**BOARD OF SUPERVISORS
BUSINESS MEETING
ACTION ITEM**

SUBJECT: **LEGI-2023-0059, Greenlin Park: ZMAP-2022-0024**

Re: Greenlin Park Response Letter
(LEGI-2023-0059; ZMAP-2022-0024)

Figure 2. Conceptual Layout – Option 1 (Sheet 3)

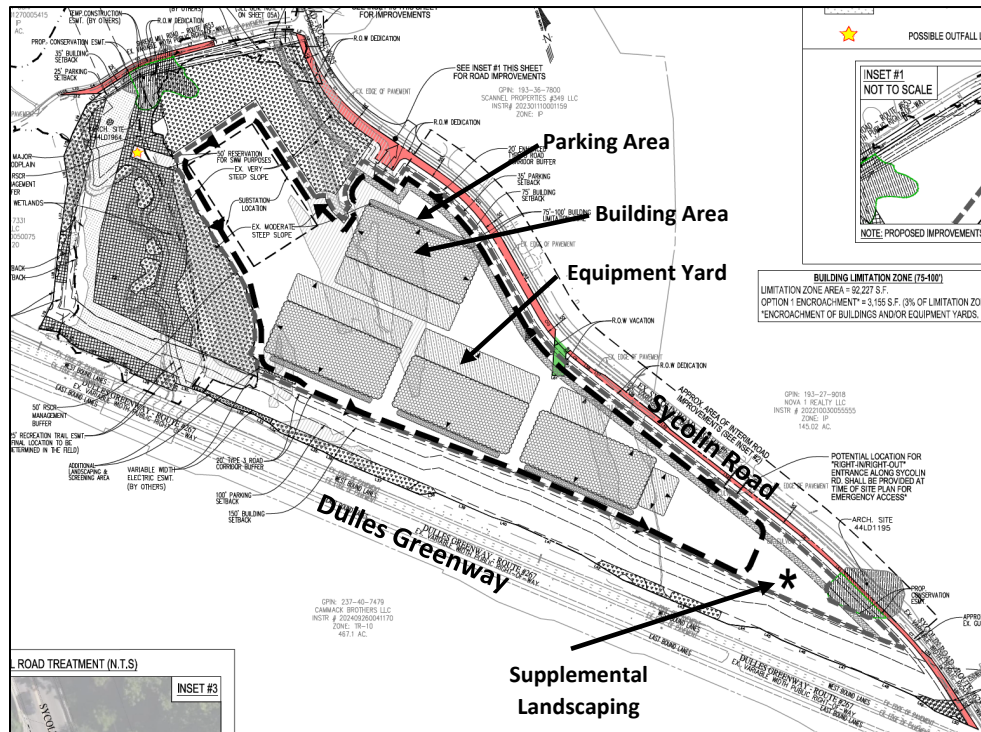
- The designs on sheet 3 and 3B has equipment yards facing Sycolin; sheet 3B would have a large amount of equipment yard/loading facing Sycolin given its size.

Figure 3. Conceptual Layout – Option 2 (Sheet 3A)

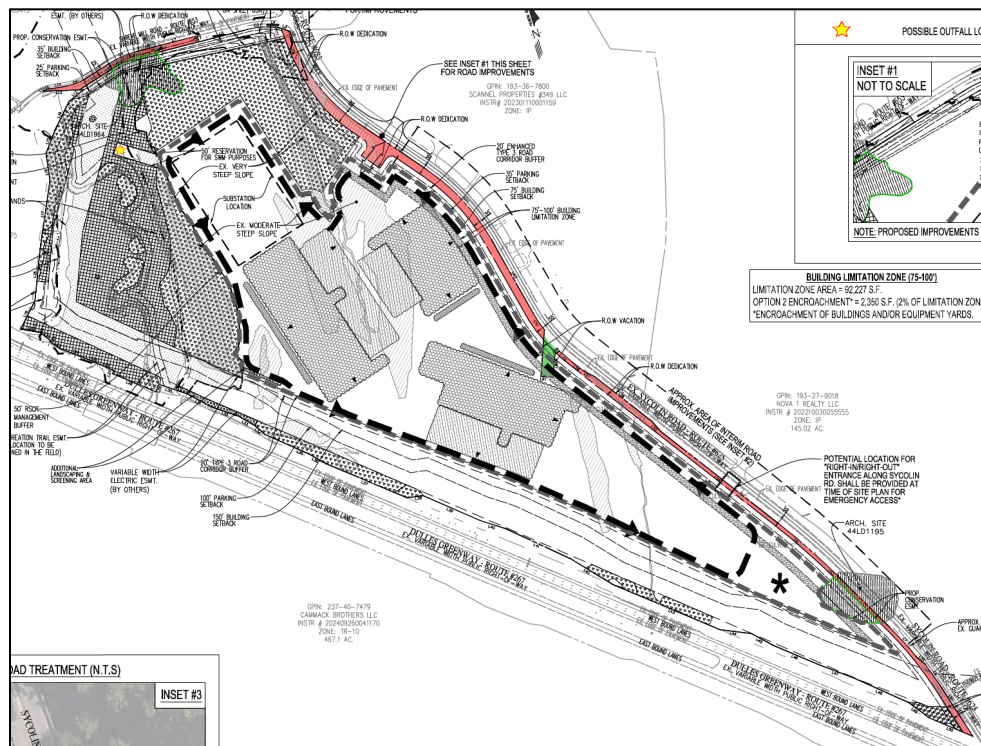
2. There are two "Option 3"s as indicated within the Sheet Title. Sheets 03A and 03B.

To address this inconsistency, the title block for Sheet 03A now states "Option 2".

BUILDING RENDERING
GREENLIN PARK
ZMAP-2022-0024, LEG1-2023-0059
LEESBURG ELECTION DISTRICT
LOUDOUN COUNTY, VIRGINIA

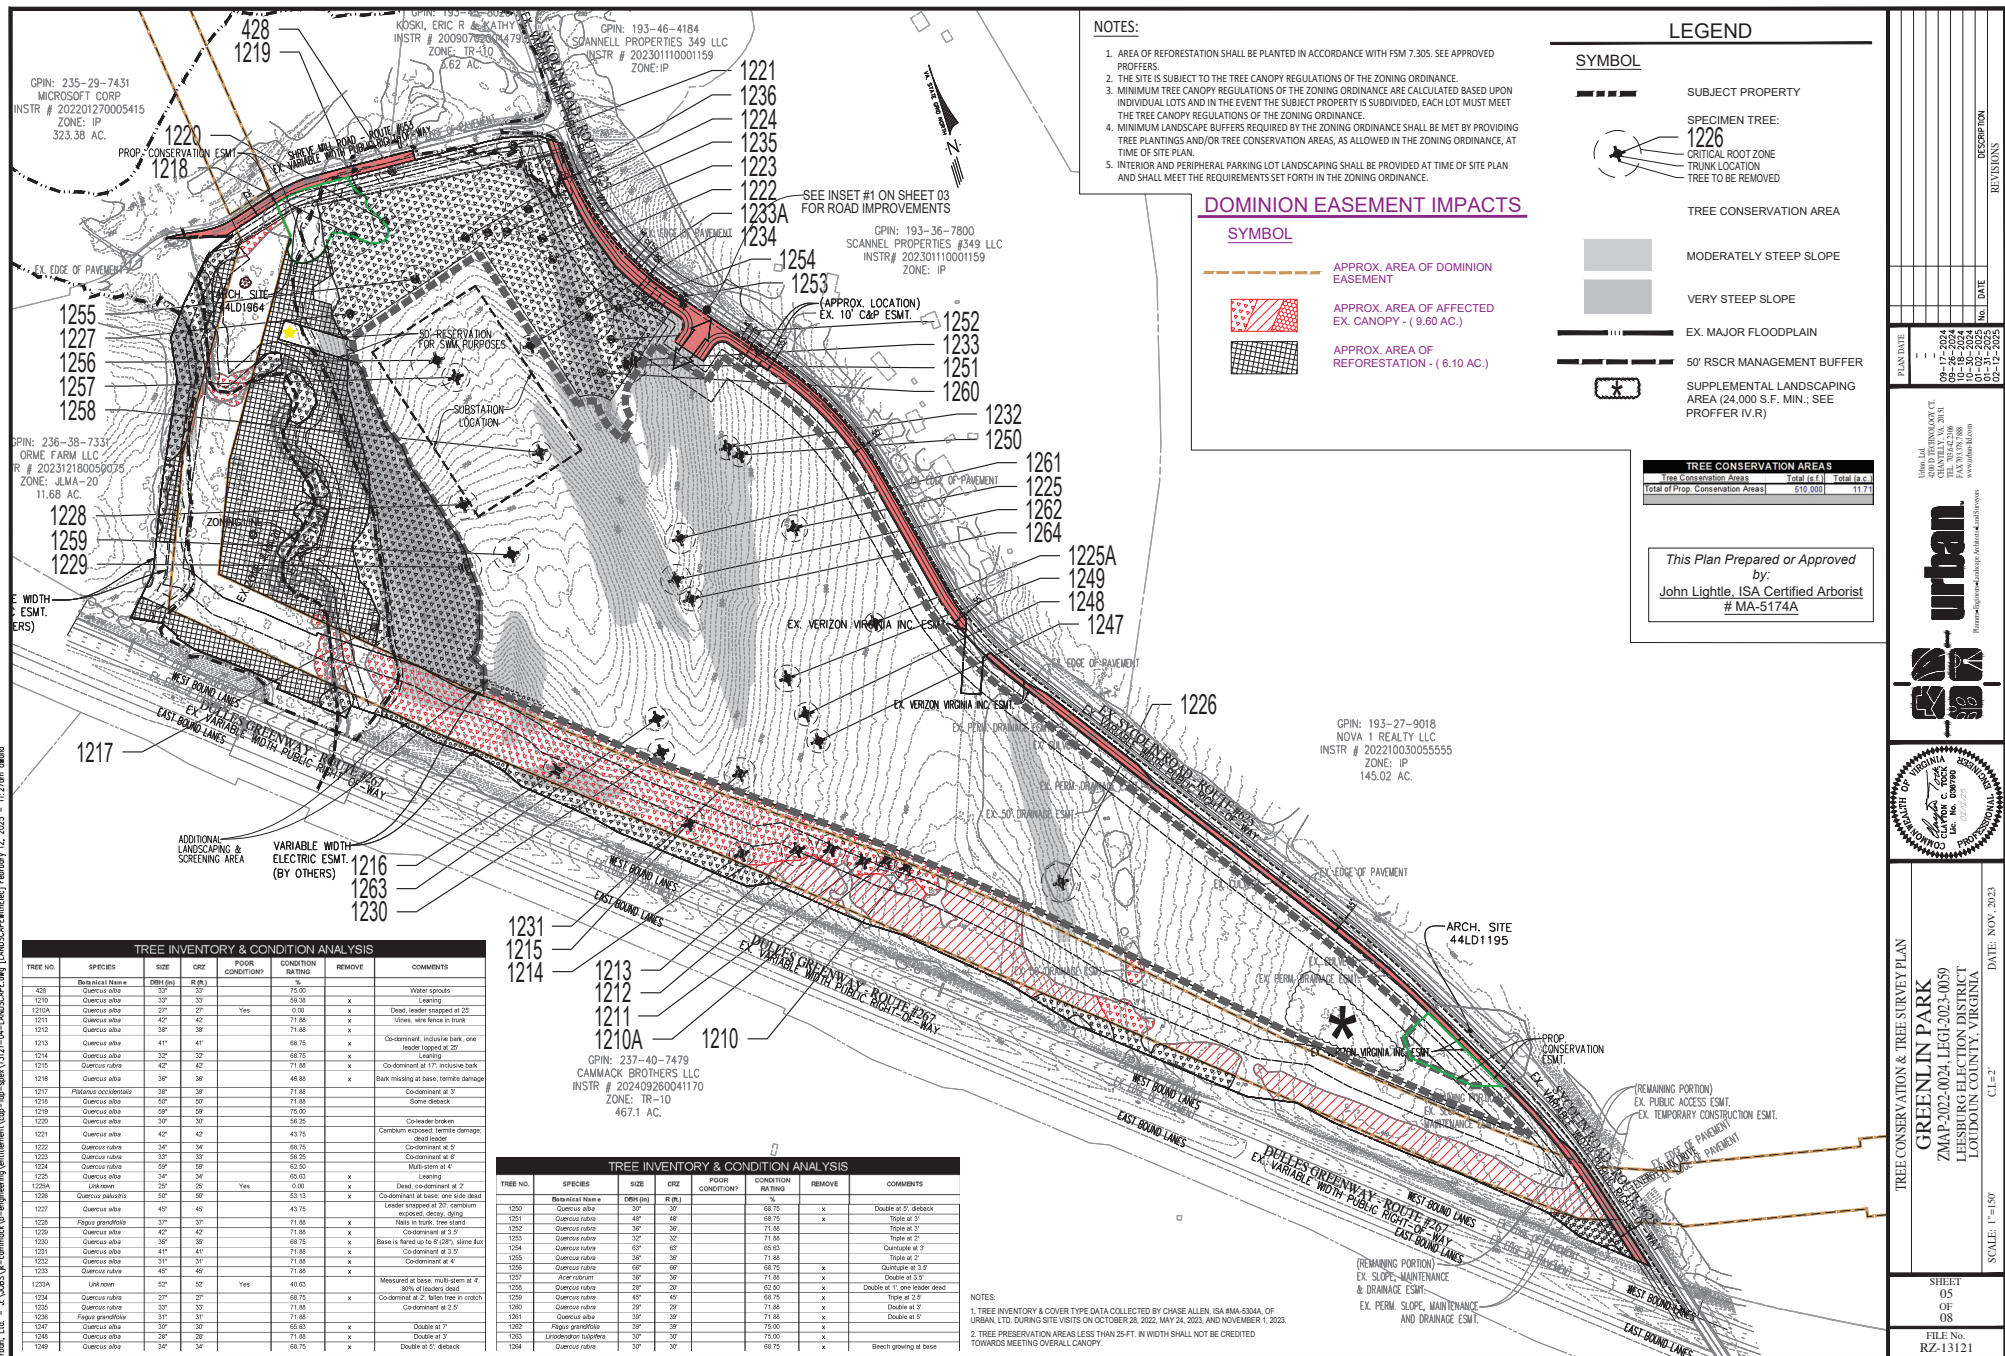
Community Planning continues to recommend a commitment to a maximum building height of three stories as envisioned in the Transition Light Industrial Place Type. Without building elevations to understand the visual impacts of the building height, Community Planning is not persuaded that 60 feet in building height conforms to the vision for the Place Type. This issue is not resolved.

The evaluation of a building design can be subjective. What the Applicant can confirm is that the building design standards required by the enclosed proffer statement reflect the data center façade standards included in the recently adopted zoning ordinance. The renderings included on Sheet 07 of the CDP are representative of the building design proffer included in the enclosed proffer statement.

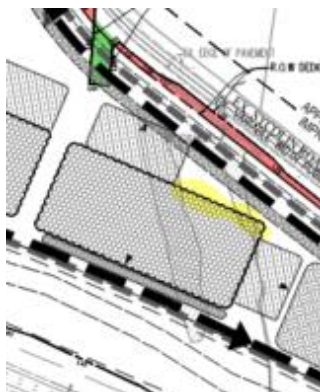
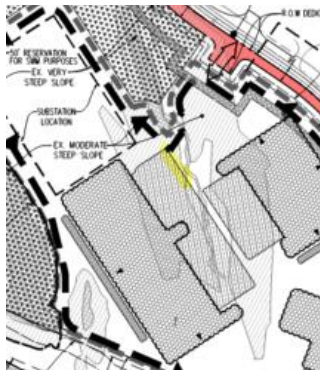
1. “Energy Storage Facility” is not a term or use defined within the R93 ZO. Remove the term from the CDP sheets. Additionally, the following note on Sheets 03, 03A, and 03B must be removed from the sheets. Note that the introduction of additional uses to a pending application after the effective date, is considered a “substantial modification” and runs the risk of losing the application’s “grandfathered” status. See #6 of the Grandfathering Rules adopted as part of ZOAM-2020-0001.

*NOTE: APPROVAL OF A FUTURE MINOR SPECIAL EXCEPTION WOULD BE NECESSARY TO ESTABLISH THE ENERGY STORAGE FACILITY IF IT'S NOT CONSIDERED A UTILITY SUBSTATION ALIGNED WITH THE ON-SITE DATA CENTERS.

The Energy Storage Facility term and the above referenced note are now removed from the CDP. Following up on the Applicant's discussion with County staff, the CDP now makes reference to this area as, "BUILDING, PARKING, AND LOADING AREA".
